FIRE SAFETY INSPECTION REPORT

ECO COUTURE LTD.

ACCORD ID: 12384

November 16, 2015

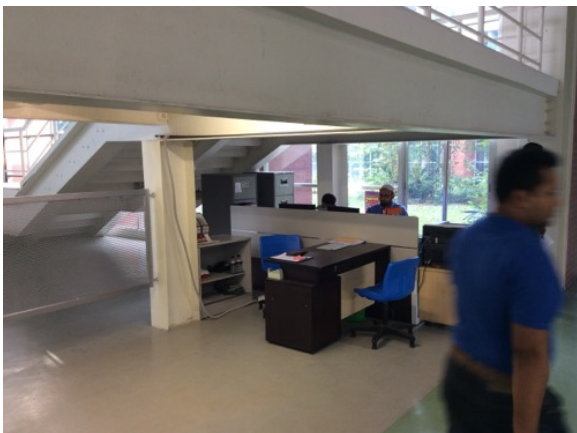
F-7	Egress	Obstructions was located in the exit stair on ground floor.	Remove all obstructions from exit stairs.	Immediately
-----	--------	---	---	-------------
